DEPARTMENT OF PLANNING AND ZONING PLANNER'S REPORT

RE: Design Review – 801 Virginia Avenue

The City of Hapeville has received a design review application from Joseph Latimer for the exterior remodel of an existing 4,962 square foot commercial building located at 801 Virginia Avenue. The new exterior will include metal siding, storefront windows, brick, and concrete masonry. The facility will be used as a catering kitchen.

BUILDING FLEVATIONS
COLOR RENDEPHICAS

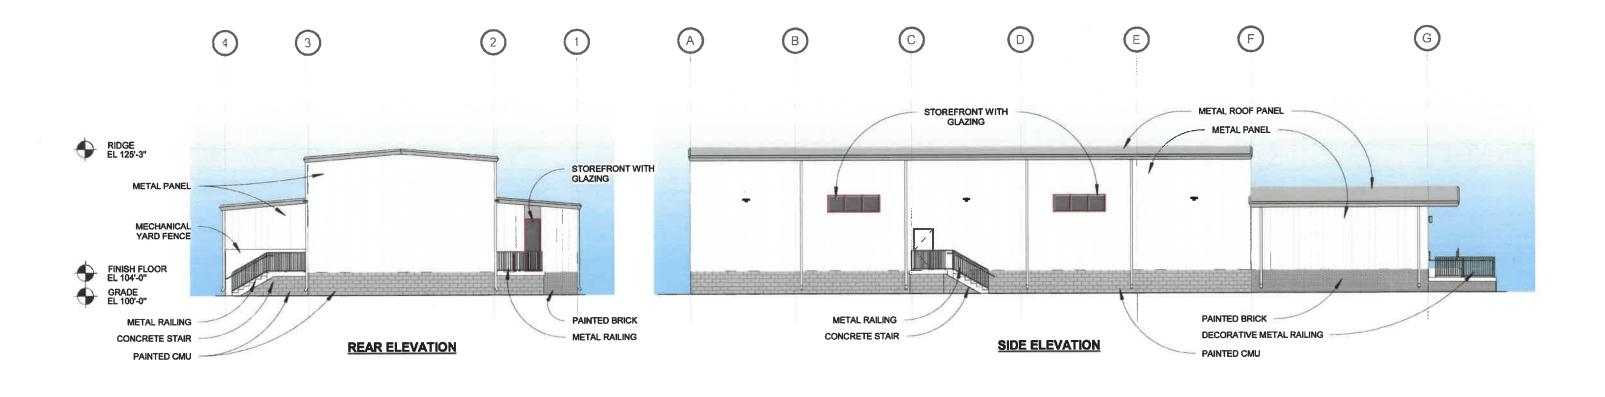
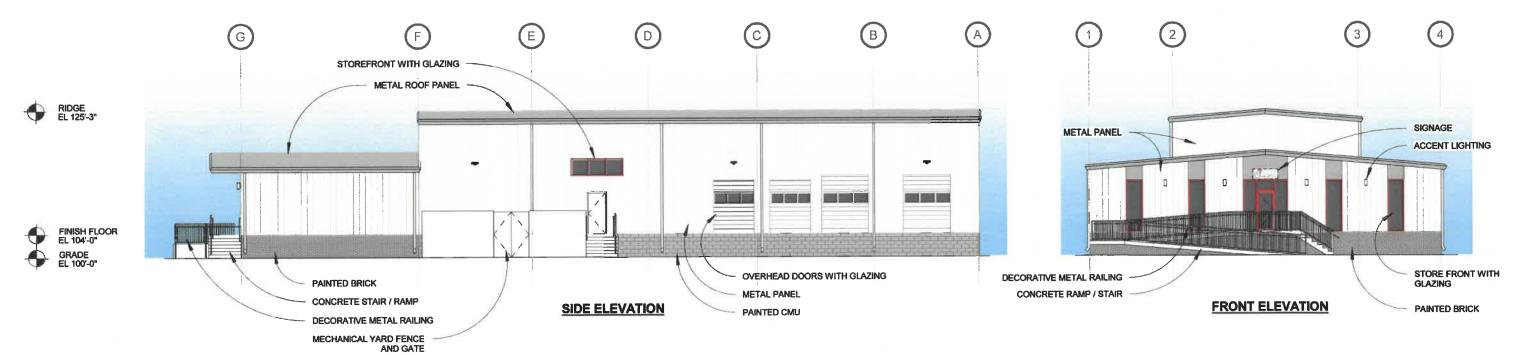
NOTES: • A design exception will be required for the use of metal panels as a façade material.

EXTERIOR ELEVATIONS

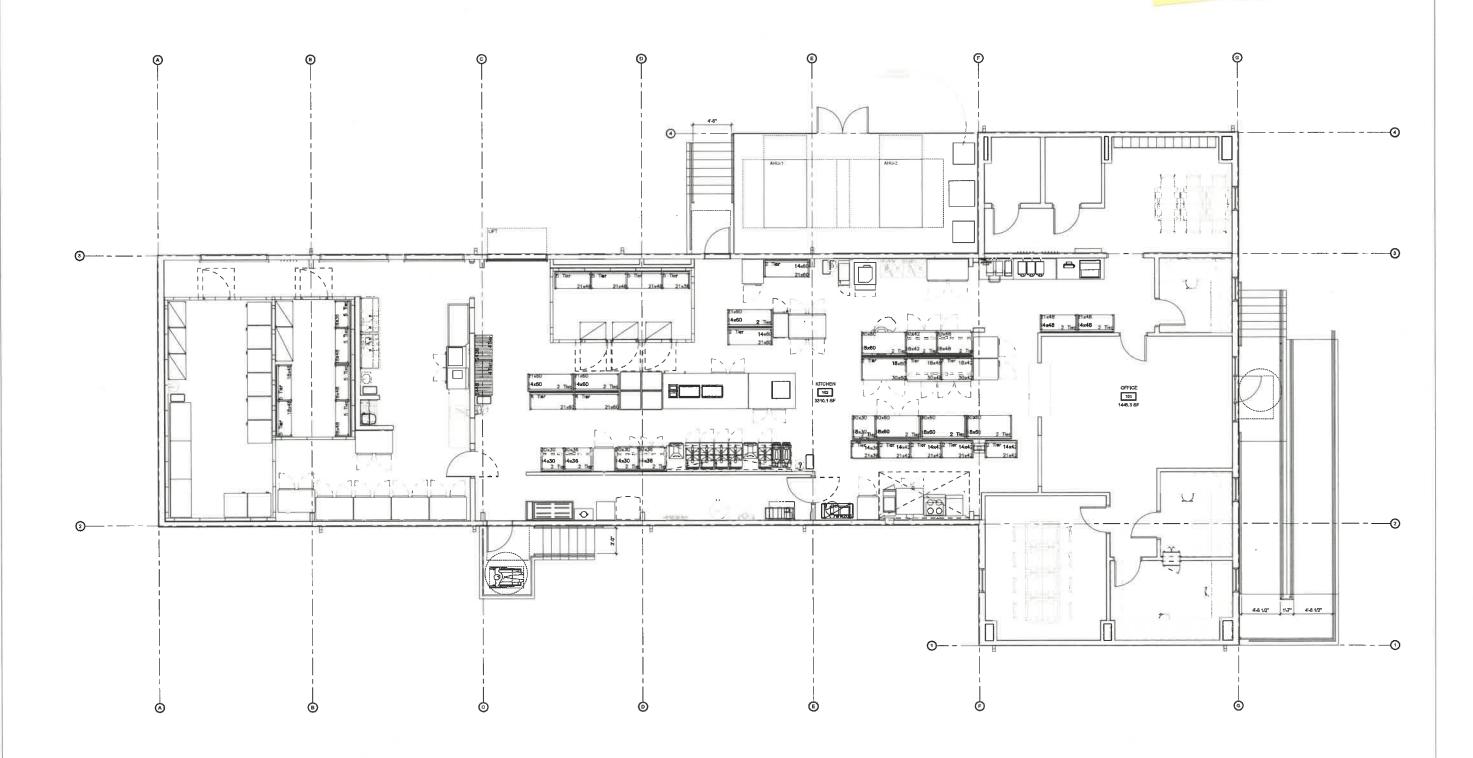
- A design exception will be required to continue use of existing storefront style and the installation of a landscape buffer instead of required "storefront and awning" style.
- The proposed 15' landscape buffer at the rear of the development is 5' narrower than the 20' required and does not provide a required permanent opaque wall.

• The applicant should provide building numbers adjacent to the front entrance.
